**RE: SEMI-ANNUAL INSPECTION – SPRING, 2025
RURAL IOWA SLF
IDNR PERMIT #42-SDP-1-72P
VERTICAL EXPANSION AREA - CLOSED
HORIZONTAL EXPANSION AREA - ACTIVE
HLW PN 6006-23A.750**

SPRING 2025 INSPECTION

RURAL IOWA SANITARY LANDFILL
ELDORA, IOWA

FIGURE: 1

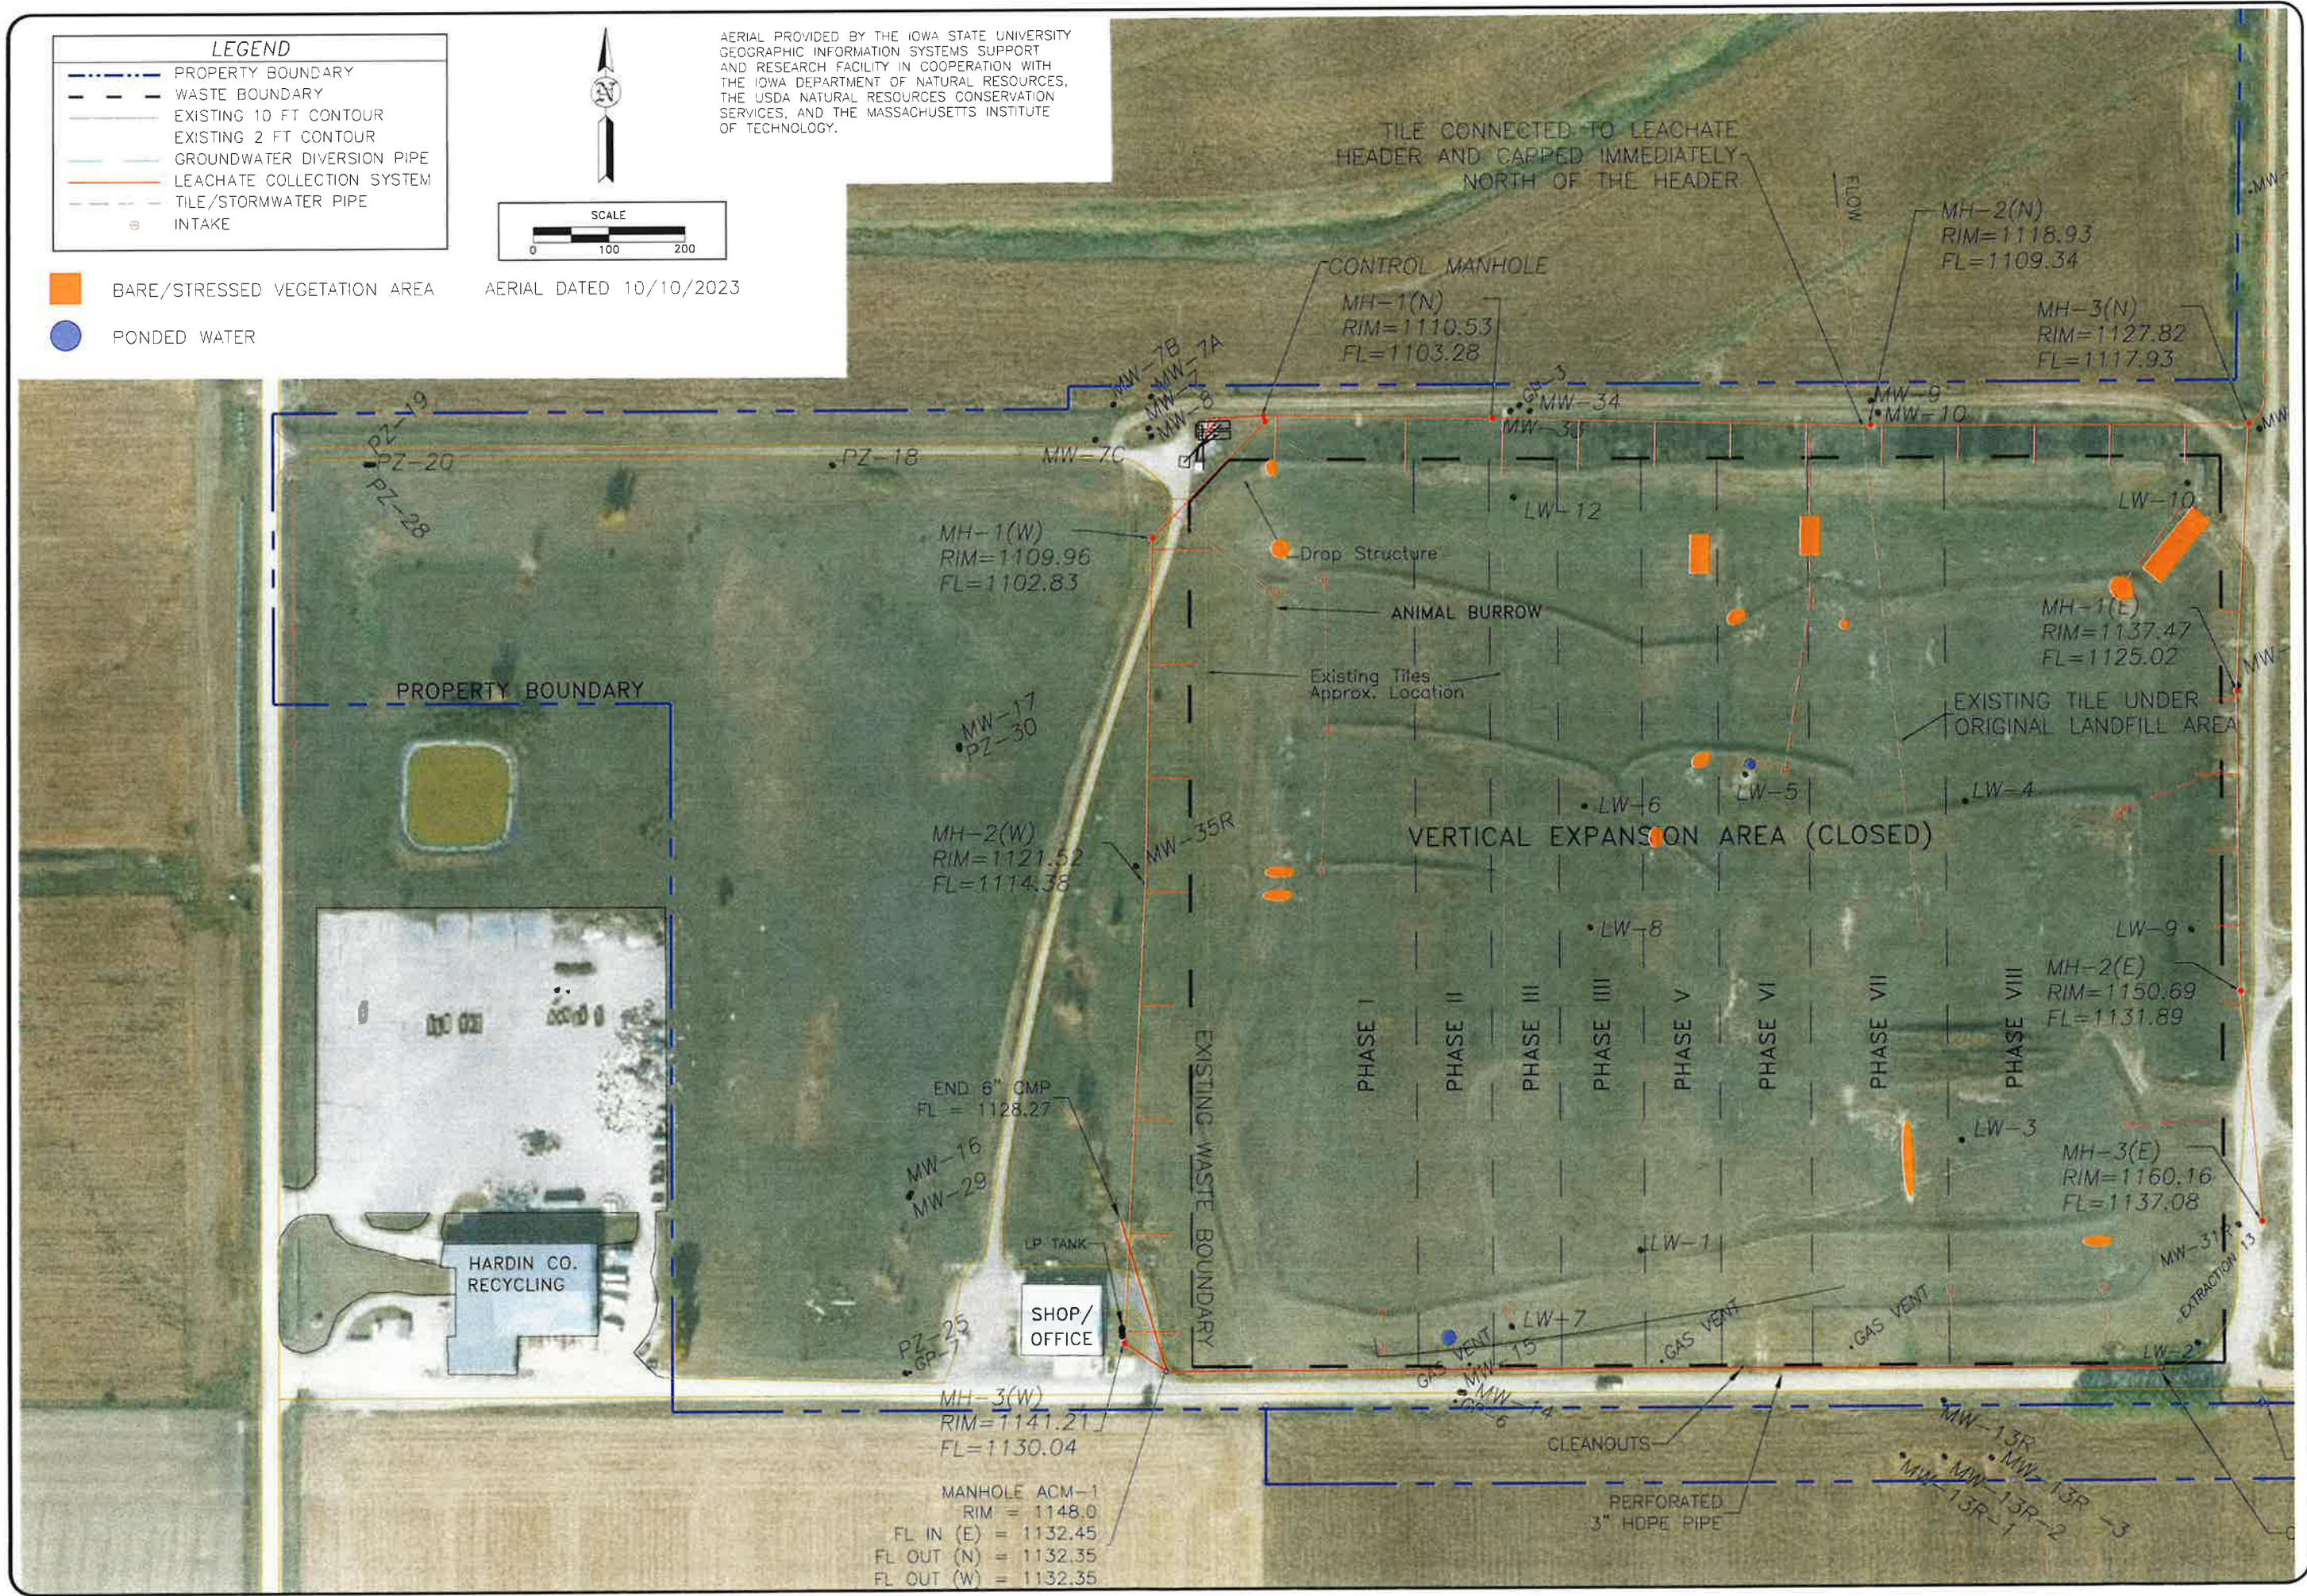
Vegetation is well established on the majority of the Original Landfilling Area although stressed vegetation/bare spots were noted in the areas shown on the attached figure with smaller areas located sporadically on the north slope. Soil has been stockpiled at several of the bare areas and will be spread when conditions allow. Mr. Krum and I discussed the option of placing clean rock in some of the areas where vegetation cannot be established to control potential erosion.

Two areas of ponded water were noted in the closed area, the approximate locations are shown on the attached figure.

1. Repair pump station and alarm system communications.
2. Eliminate ponding on the closure cap.
3. Continue to retrieve windblown litter.
4. Install passive gas vents.
5. Remove sediment from the ditch west and north of Trenches 1 and 2.
6. Collect annual stormwater sample.
7. Remove the stained rock surfacing at the pump station.
8. Seed the bare/thin areas on the closure cap, intermediate cover, and the lower sediment basin.
9. Continue tree removal as needed, monitor stumps for regrowth, and treat stumps as needed.
10. Monitor level of sediment in sediment basins, ditch checks, and other sediment control structures and remove sediment as needed to maintain capacity.
